EASTGATE COMMERCIAL PARK, PHASE II

FINAL DEVELOPMENT PLAN

Re: Project 611-659 Eastgate Commercial Park, Phase II – Final Development Plan

RE: Project 611-659 Eastgate Pkwy Final Development Plan

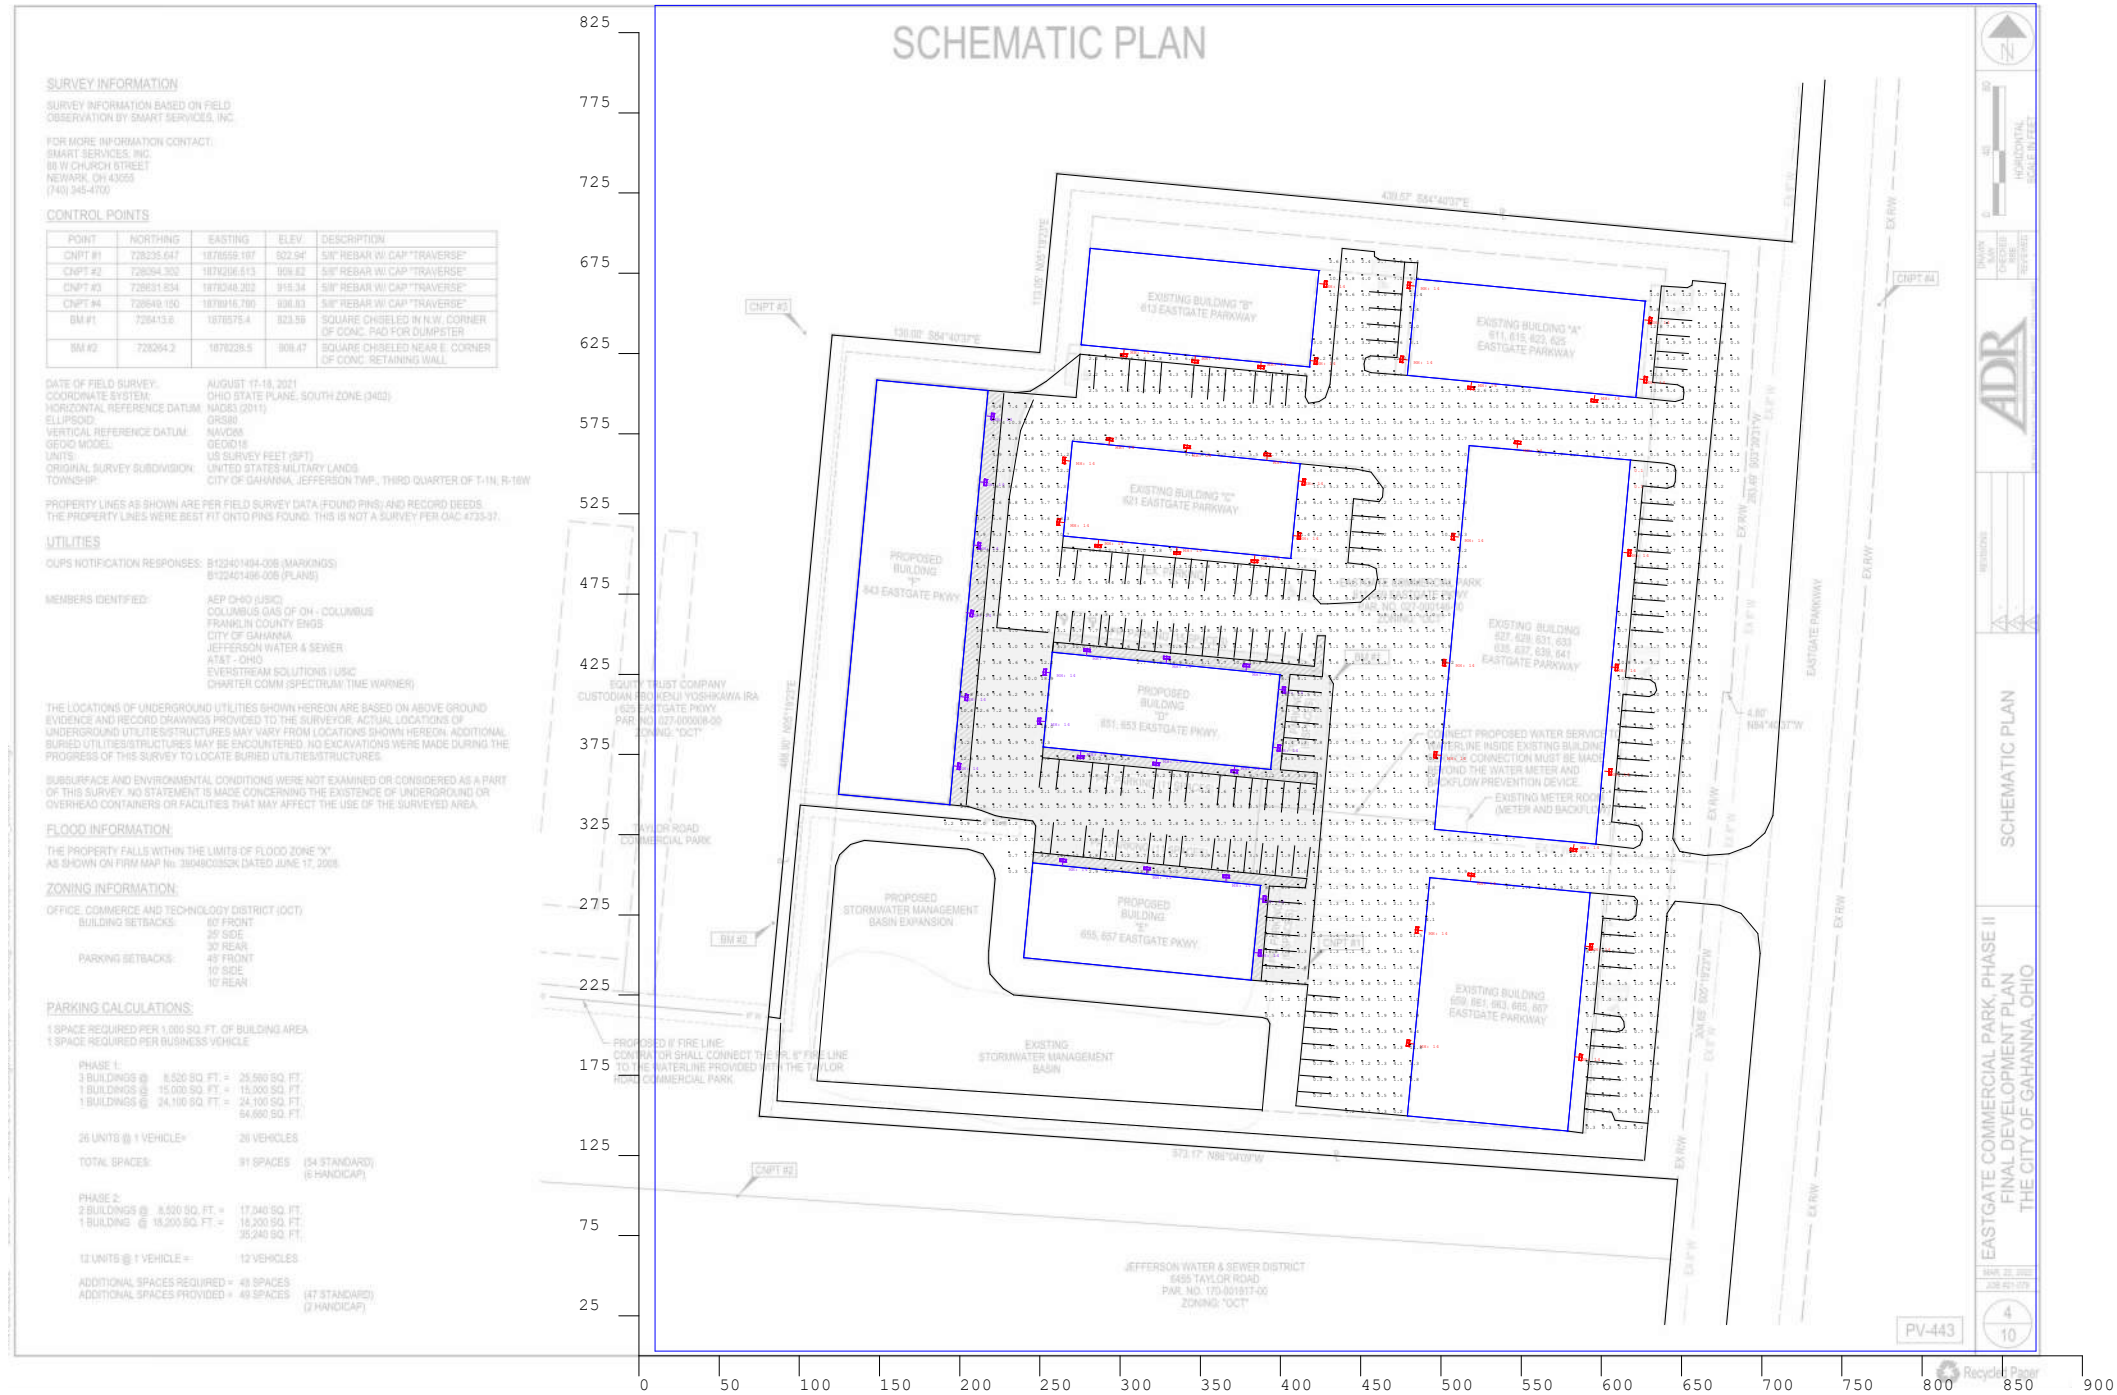
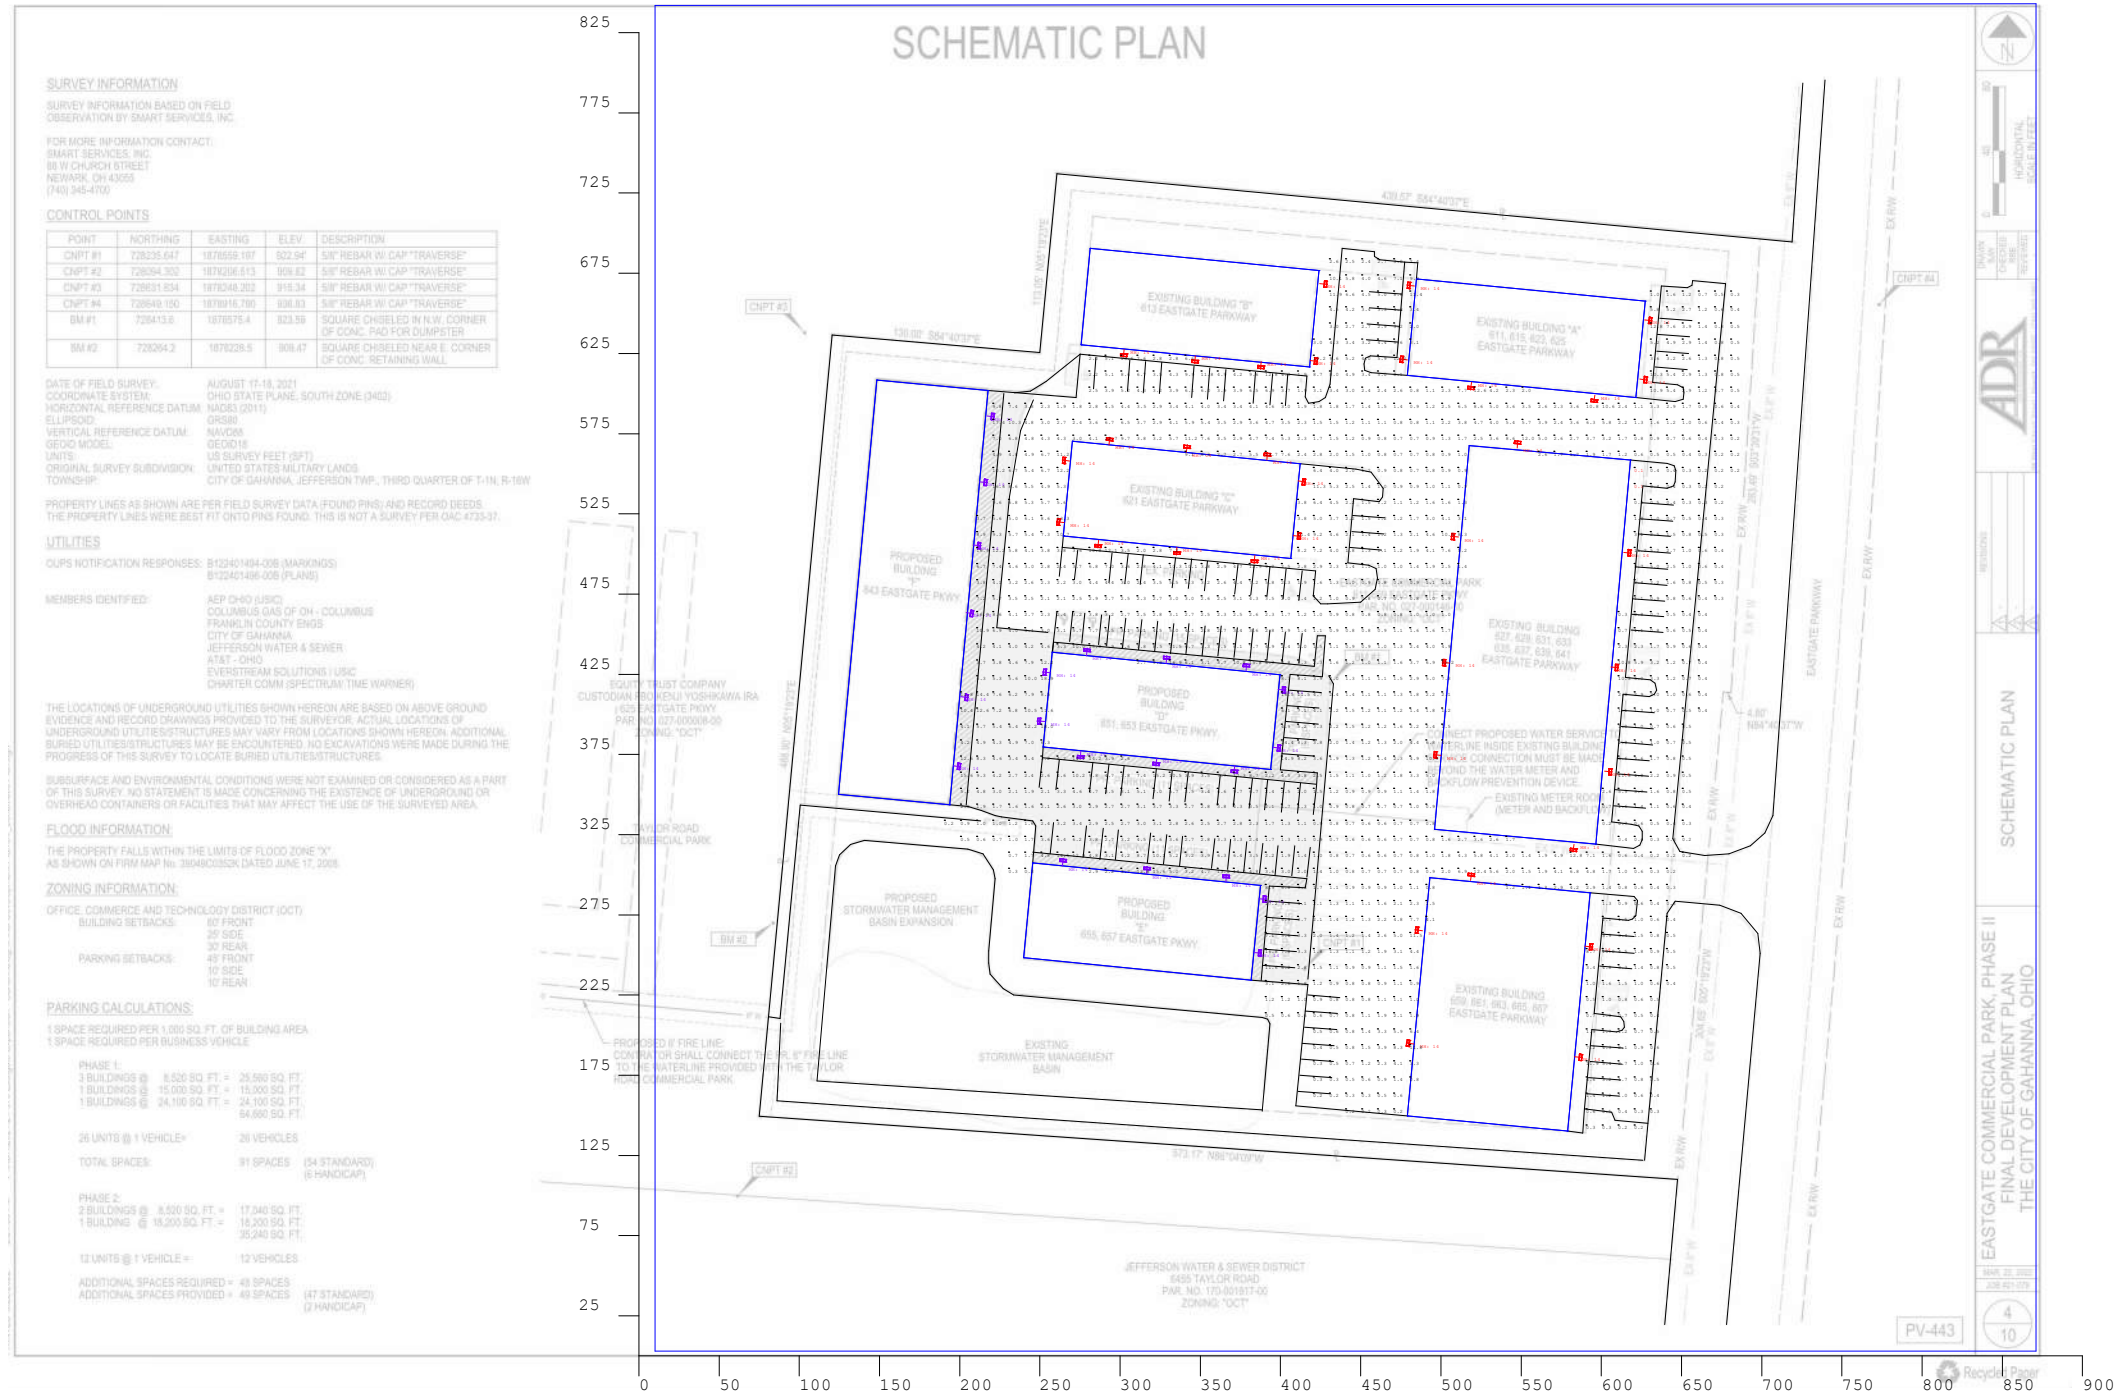
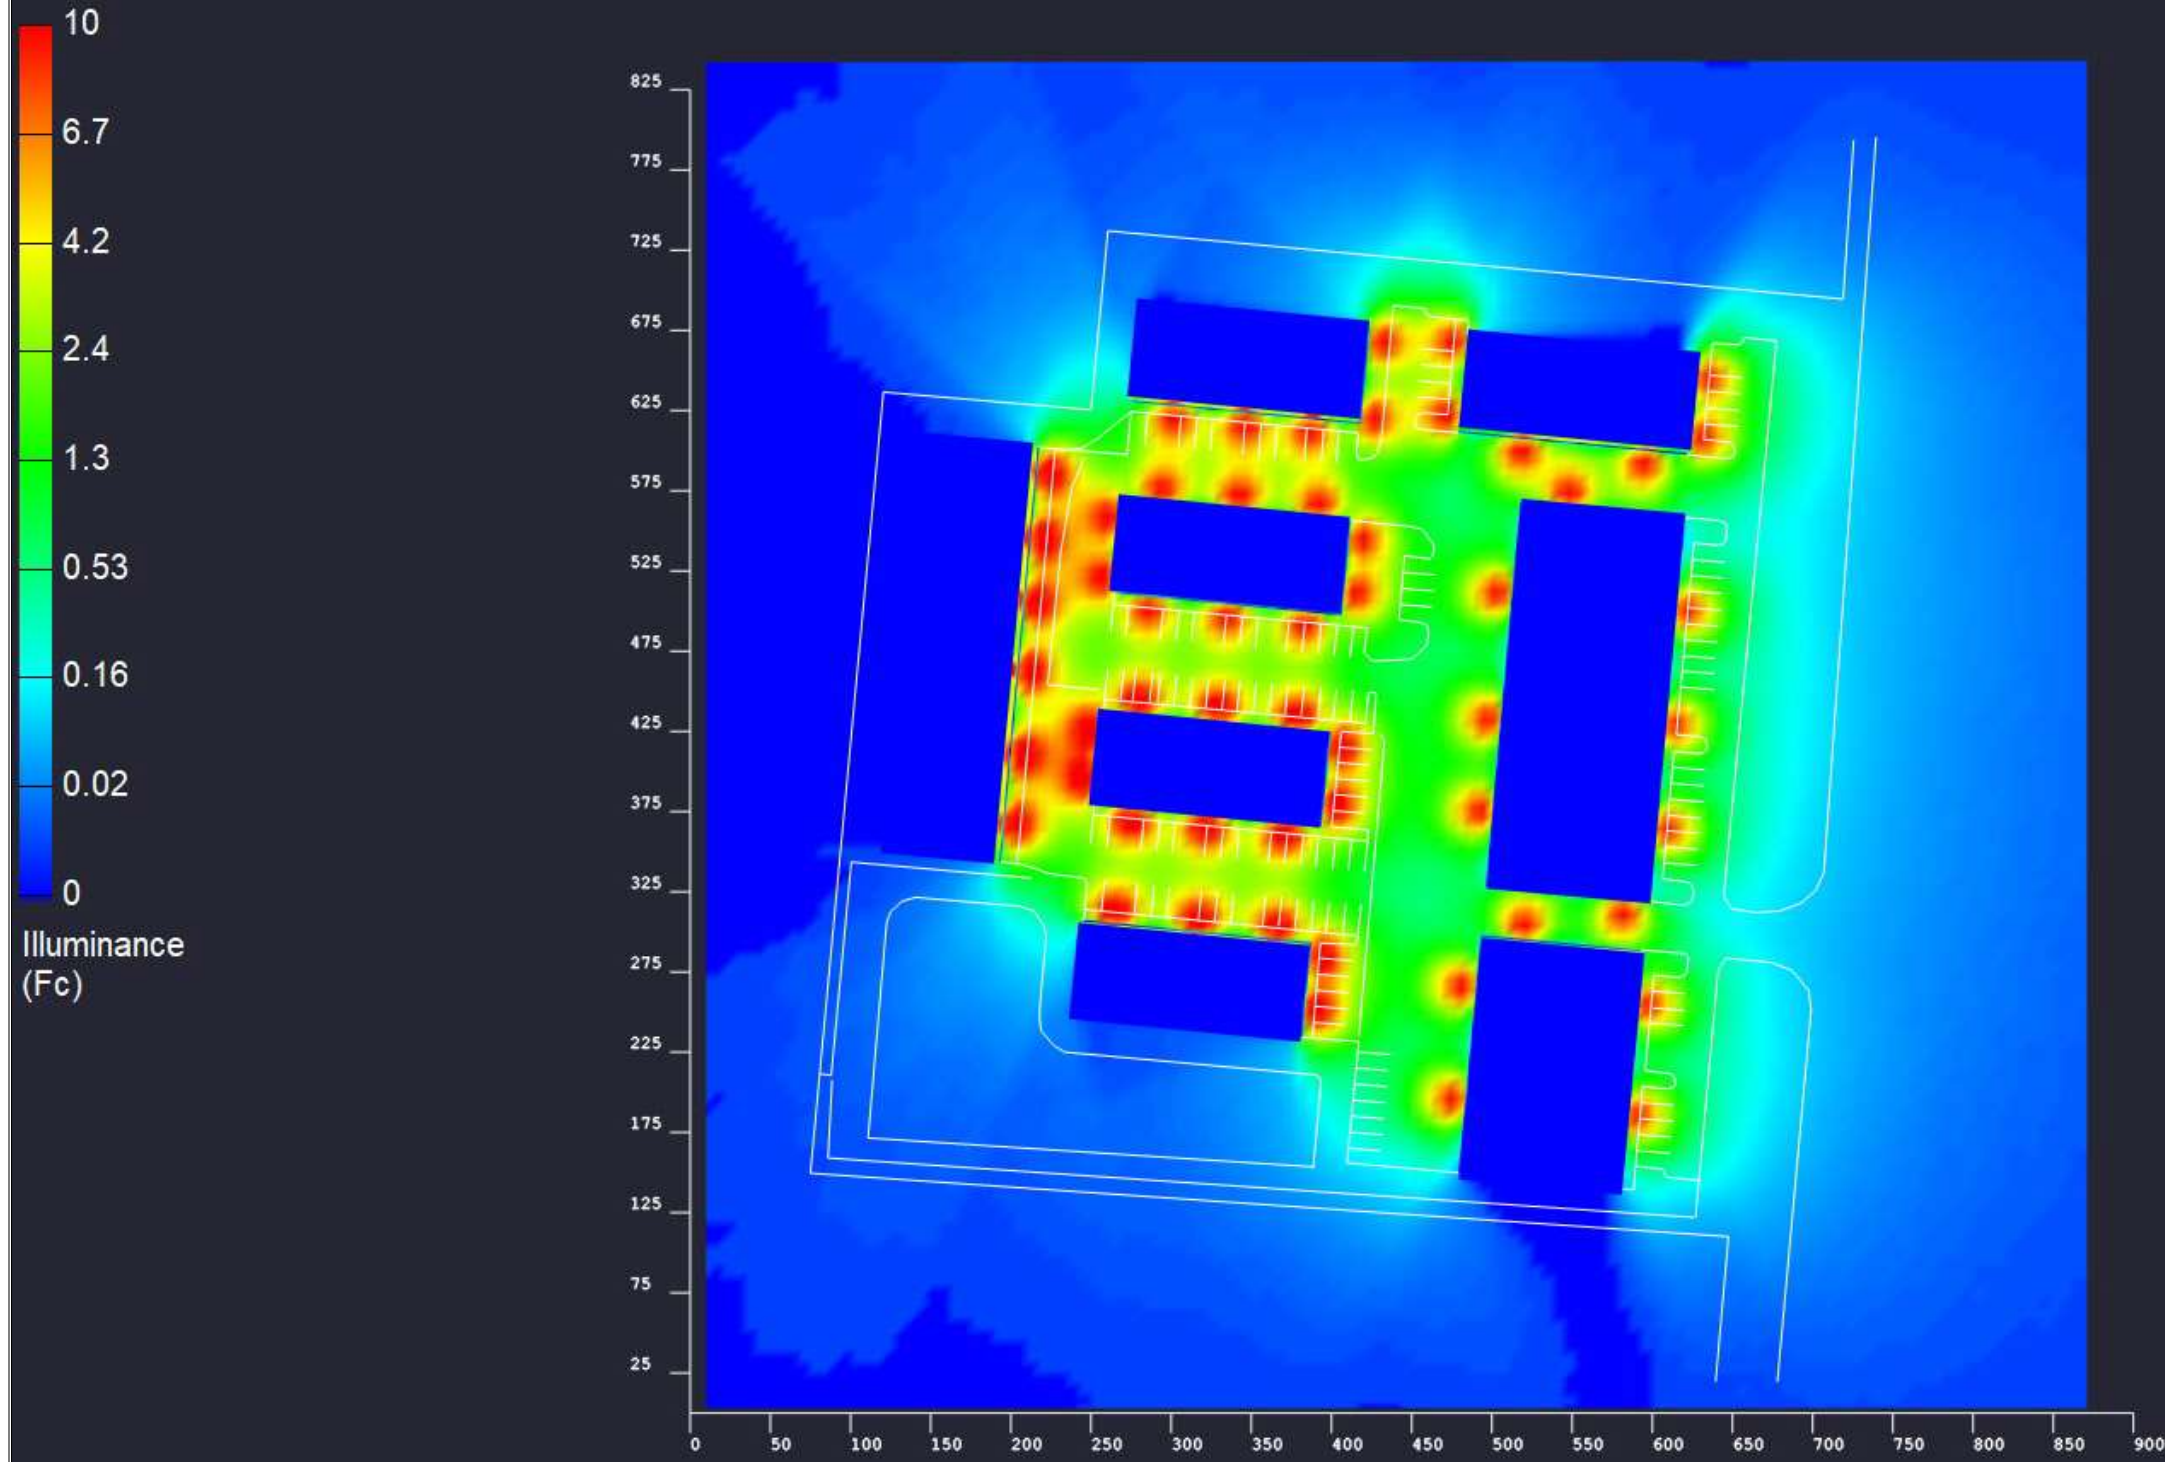
6. Label parking lot lighting as required per Section 1163.06 and 1155.08. Please note the proposed footcandles.
All proposed lighting will be wall mounted. Lighting sheet added.

4. Label parking lot lighting as required per Section 1163.06 and 1155.08. Please note the proposed footcandles. The submitted lighting plan shows the previously approved building layout - not the proposed layout with the large 18,200sqft building. Update the plan to reflect the new layout. *Updated Accordingly.*
